**WHEELING PLAN COMMISSION
THURSDAY, MAY 10, 2018 6:30 P.M.**

**AGENDA FOR A REGULAR MEETING OF THE PLAN COMMISSION
to be held in the Board Room of the Village Hall
2 Community Boulevard, Wheeling, Illinois**

RE: **Docket No. PC 18-5**
Heritage Park
100 Community Boulevard
Minor Site Plan & Appearance Approval of a Playground

RE: **Docket Nos. 2018-7 and PC 18-6**
Wieland Metals
567 Northgate Parkway
(2018-7) Variation from Title 19, Zoning, Regarding
Required Parking
(PC 18-6) Site Plan & Appearance Approval for a Building
Addition

PROJECT TITLE
WIELAND FACTORY EXPANSION
567 NORTHGATE PARKWAY
WHEELING, IL. 60090
G & R PROJECT NO: 1721.00

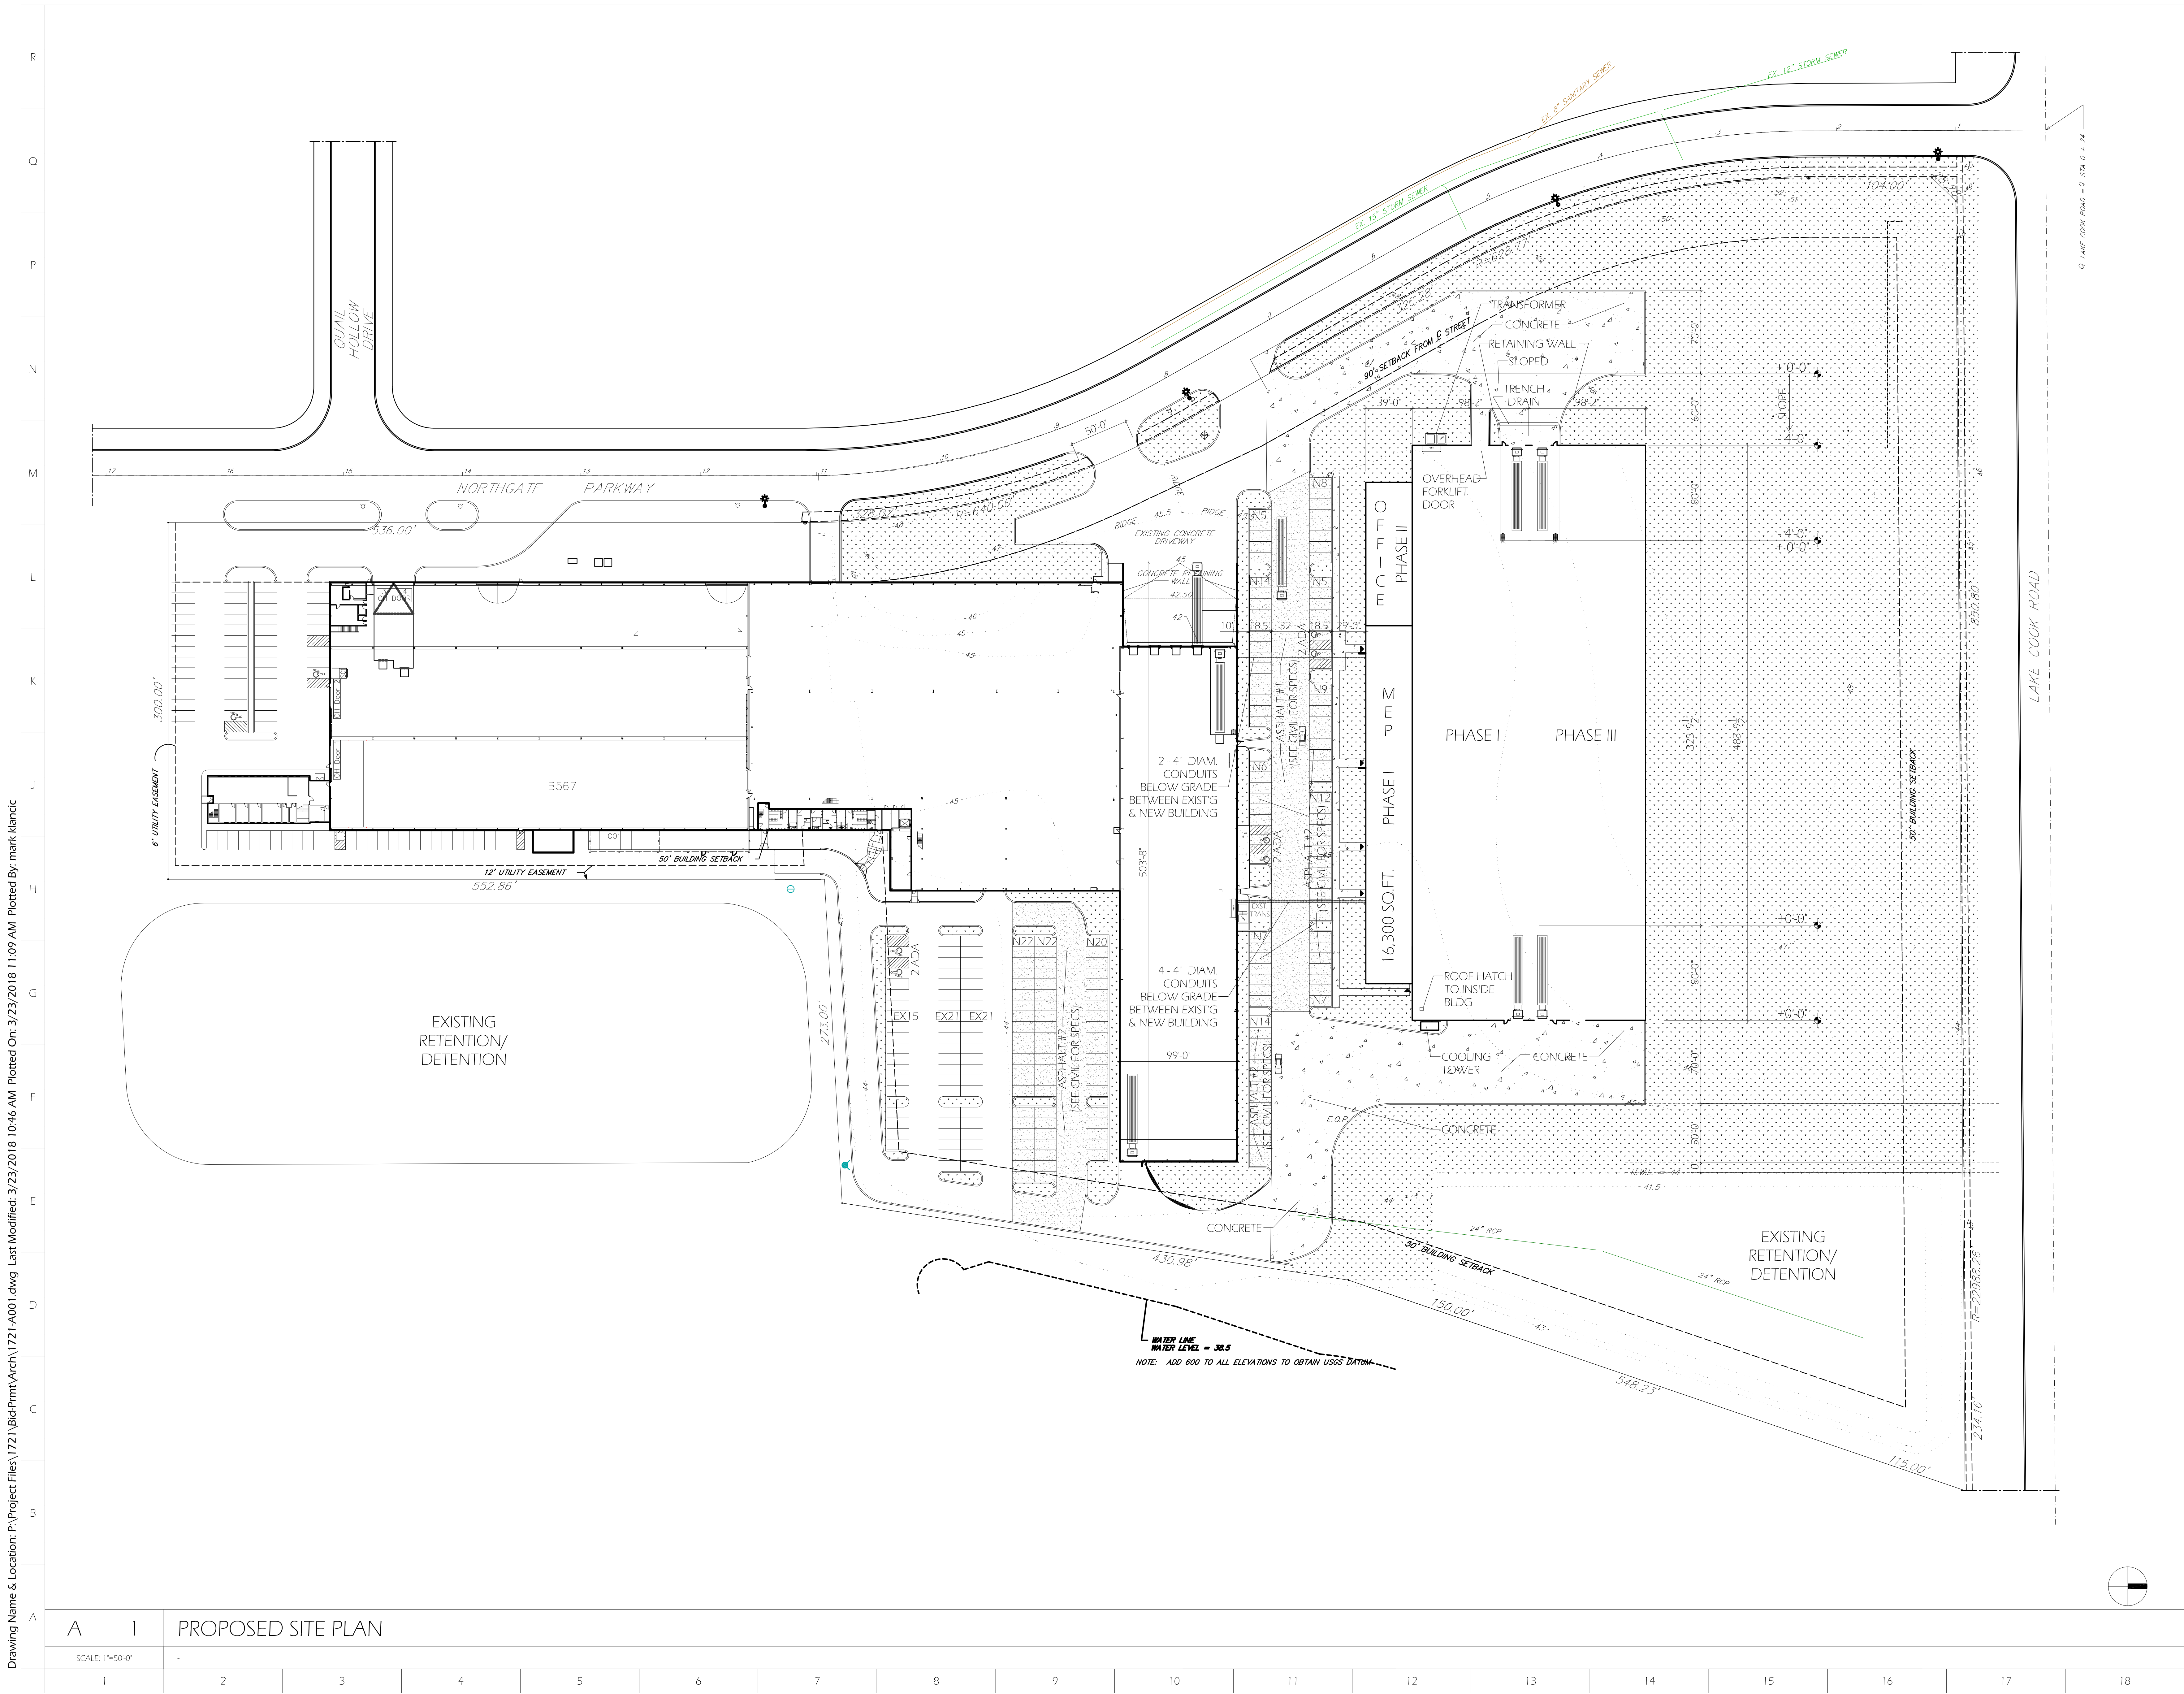
1. The site plan reviewed includes a new 101,204 square foot production facility with offices.
2. The address included with the submittal documents, 567 Northgate Parkway is the address for the office at the existing Wieland Metals building and not the address of the proposed structure. The Village has not yet assigned an address for this parcel and building.

- a. Two new parking spaces in front of the existing FDC at 667 Northgate Parkway need to be removed to provide access to the FDC. This area would then need to be posted as a "Fire Lane".

WIELAND METALS
567 NORTHGATE PARKWAY, WHEELING IL. 60090
CIVIL SITE - DIMENSIONAL CONTROL PLAN

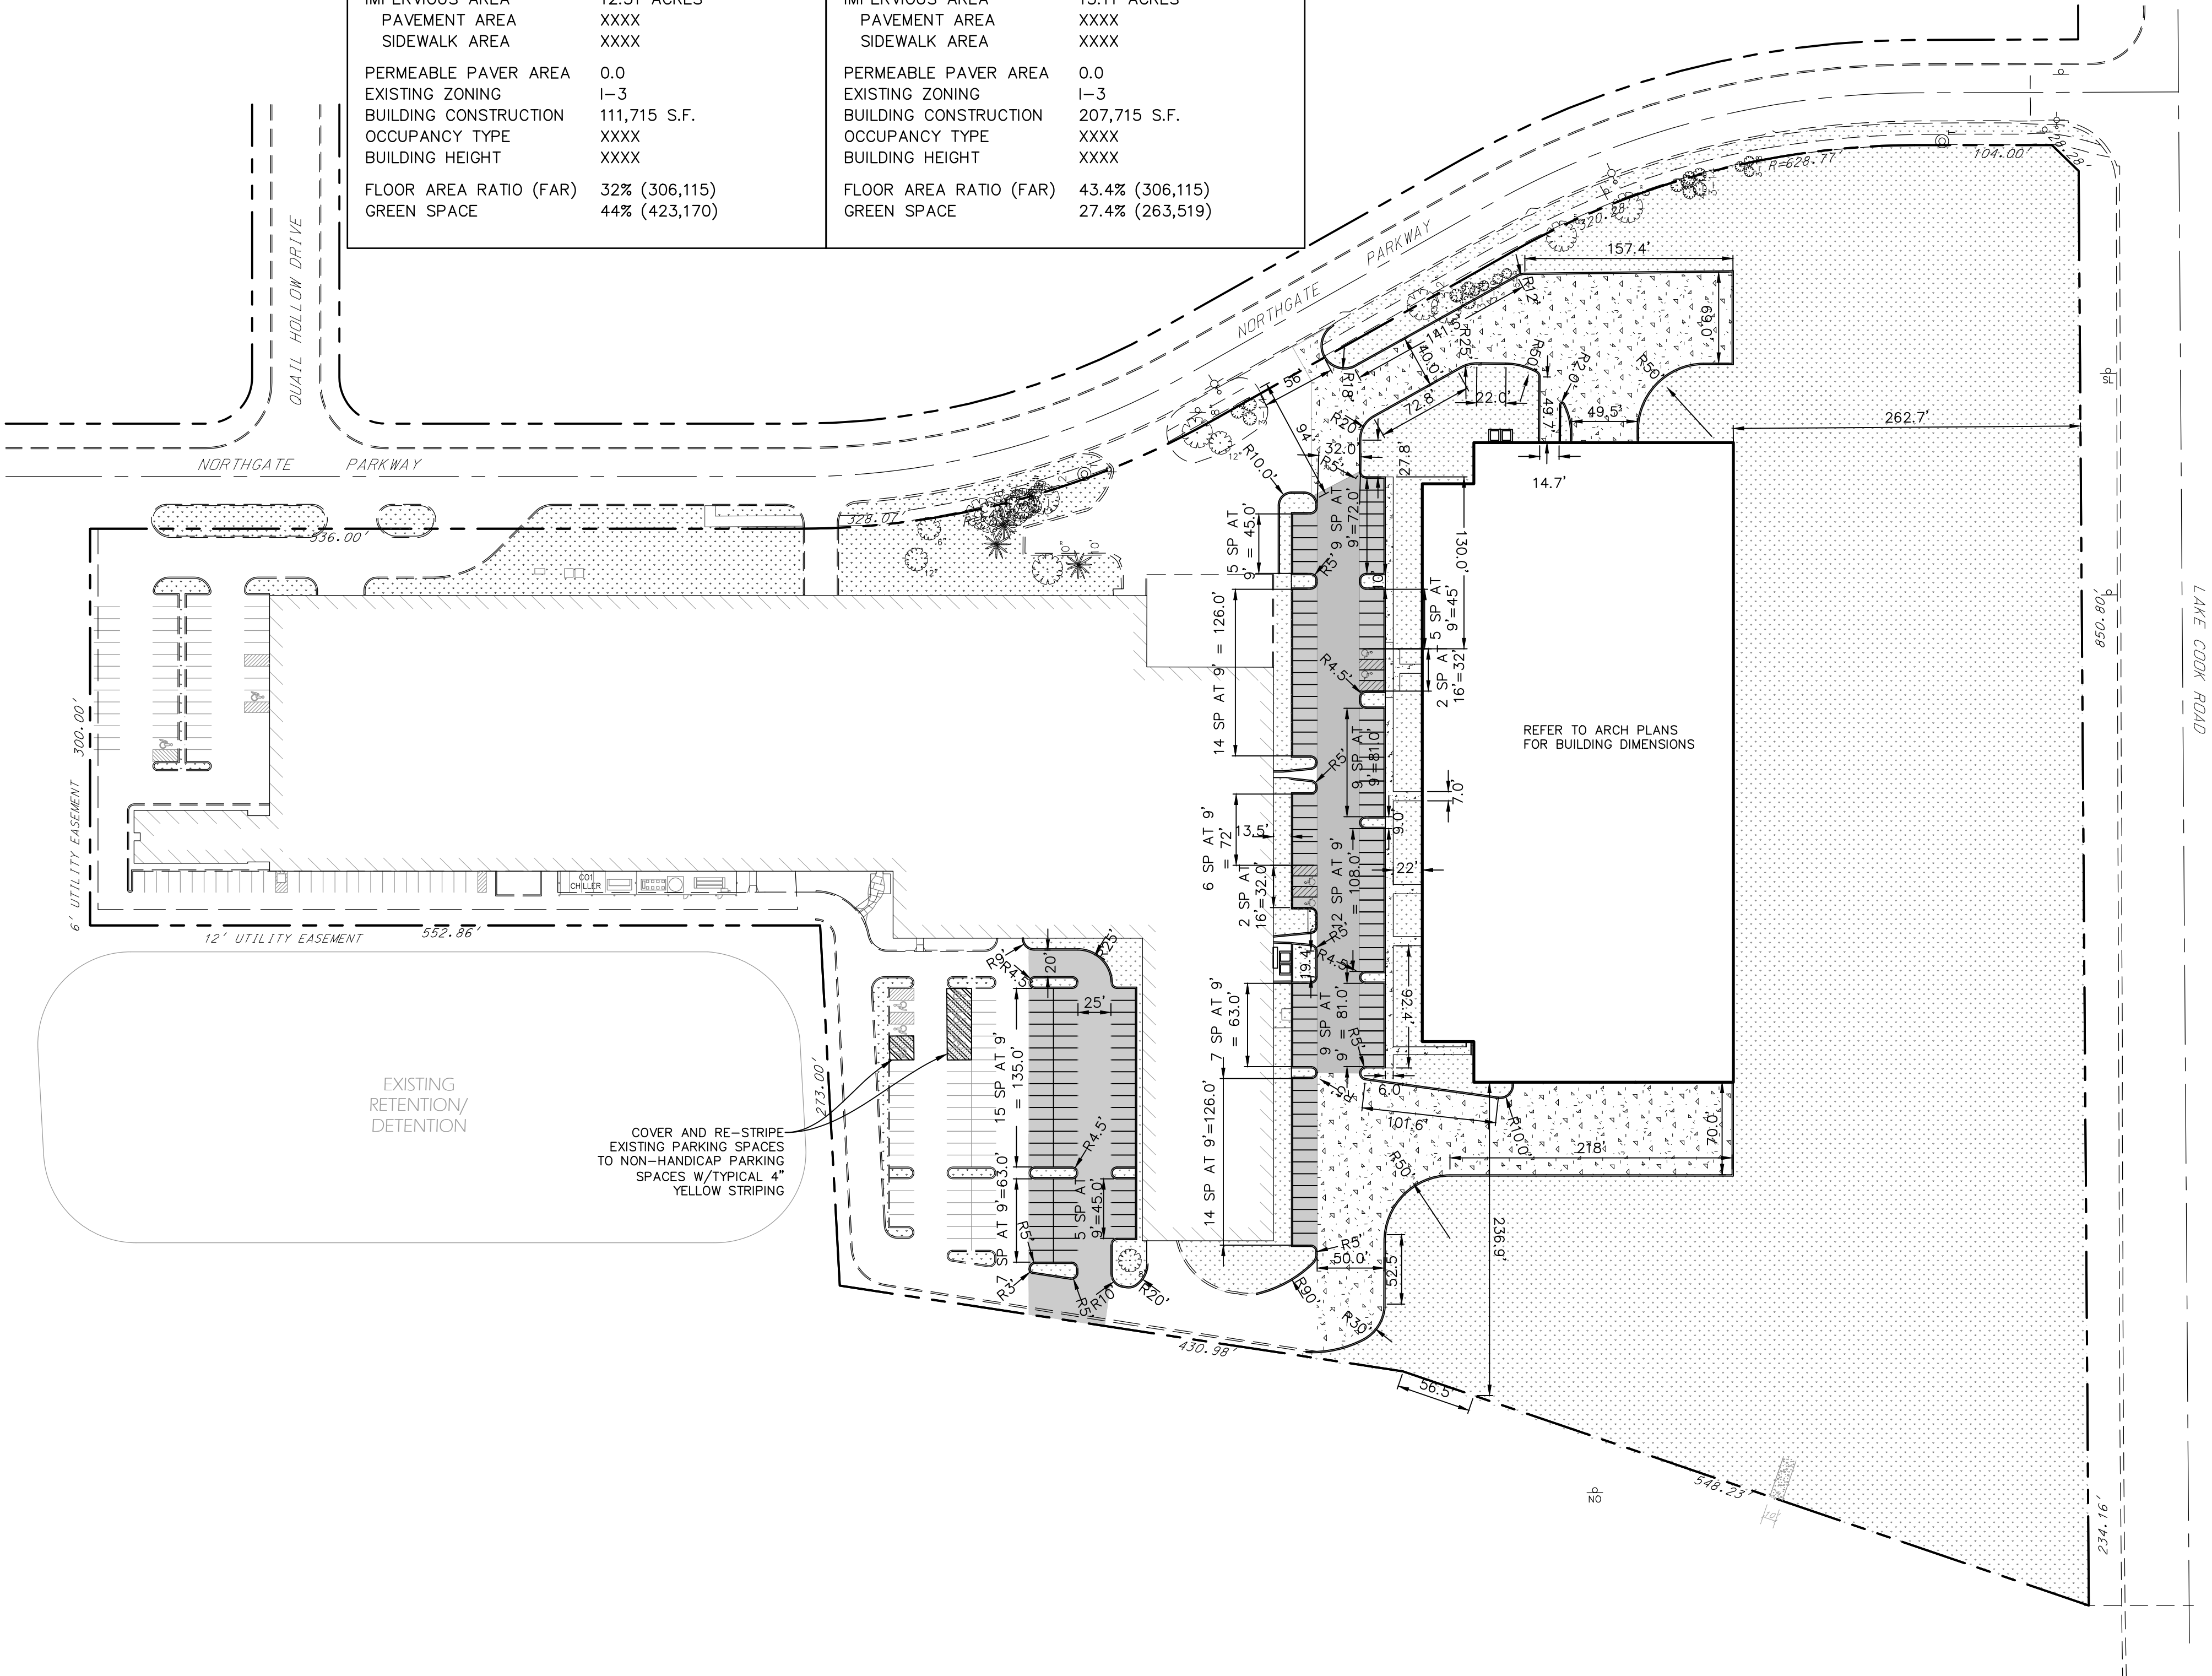
16. All utility separation requirements will adhere to the Standard Specifications for Water and Sewer 2014.
17. Pavement cross sections varies from our standard detail. Our parking lot detail on sheet 10 shows 2" of binder and 2" of surface course. The legend on the paving plan (sheet 7) show 2 ¼" binder and 1 ½" surface for low and medium duty profiles.
